August 12, 2025 Storhaug Engineering C/O Clifton Trimble on behalf of Latah Glen, LLC. 510 E 3rd Ave. Spokane, WA 99201

RE: Review of File # Z25-371PPLT (Initial Agency Review) DRAFT LETTER

From sewer drawing.

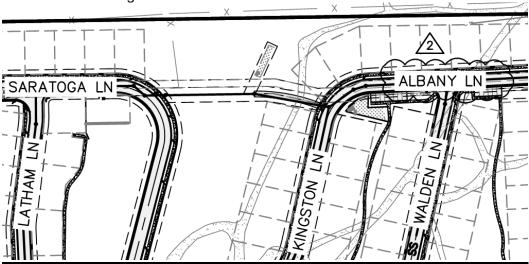
A. It appears they have left off the utility easement for both water and sewer in parallel from Saratoga to Albany. Easement will need to be 30' wide, not 16' wide, and should be within a utility tract for boundary definition. (M. Owen Note: A new separate easement will need to be recorded and documented on the plat map prior to final plat approval per M. Owen Conversations with Eldon Brown.)

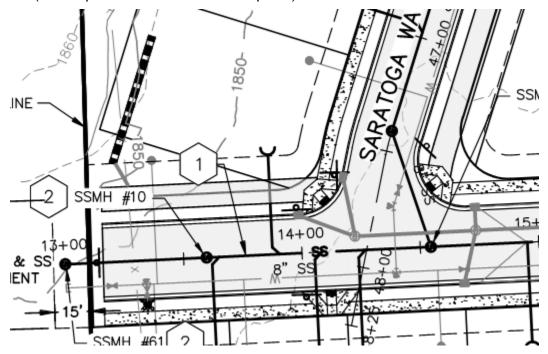
- 2. The information for Lot 5 Block 10 is covered by duplicate text for Tract 12. Please remove from Lot 5 Block 10 (also identified by planning).
- 3. Add "TRACT 3" label to sheet 2 for clarity.
- 4. The "PATH EASEMENT" on Lot 3 Block 16 should be better defined so as not to encumber the entire lot with a blanket easement.

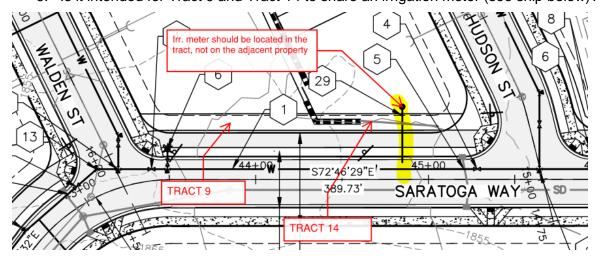
- Planning Note M. Owen: it appears that the above condition may also exist over several tracts, please work with engineering on any updated to easement detail that may be needed related to tracts.
- 5. A sewer easement will be required for the proposed sewer connection to Lot 3 Block 16 (see snip below from construction plans).

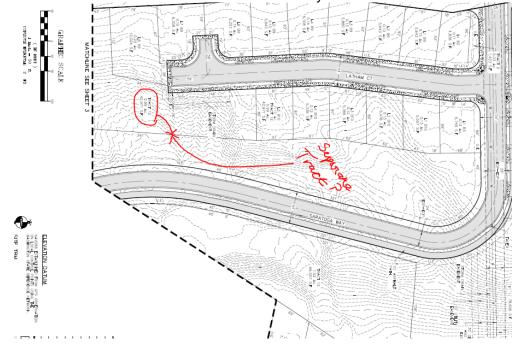
10. The below right of way width appears to be incorrect.

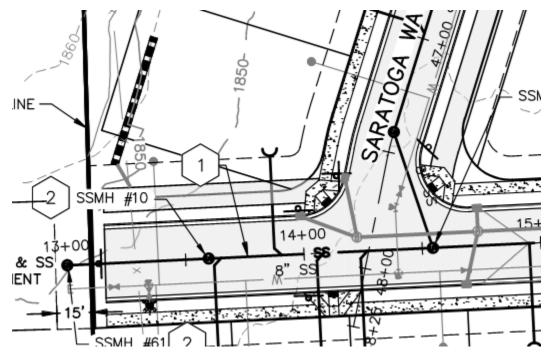
- 2. The information for Lot 5 Block 10 is covered by duplicate text for Tract 12. Please remove from Lot 5 Block 10.
- 3. Add "TRACT 3" label to sheet 2 for clarity
- 4. The "PATH EASEMENT" on Lot 3 Block 16 should be better defined so as not to encumber the entire lot with a blanket easement.
- 5. A sewer easement will be required for the proposed sewer connection to Lot 3 Block 16 (see snip below from construction plans).

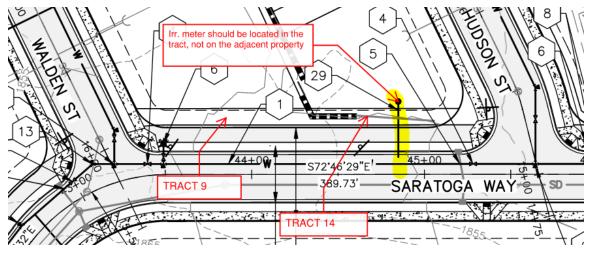
6. Is it intended for Tract 9 and Tract 14 to share an irrigation meter (see snip below)?

From sewer drawing.

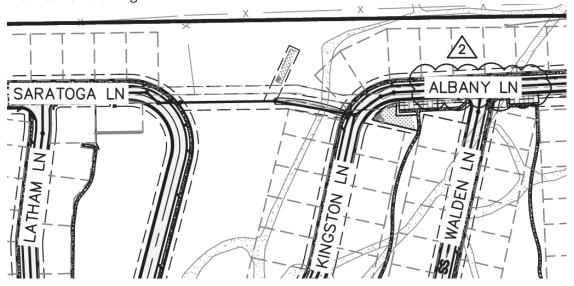
It appears they have left off the utility easement for both water and sewer in parallel from Saratoga to Albany. Easement will need to be 30' wide, not 16' wide, and should be within a utility tract for boundary definition.
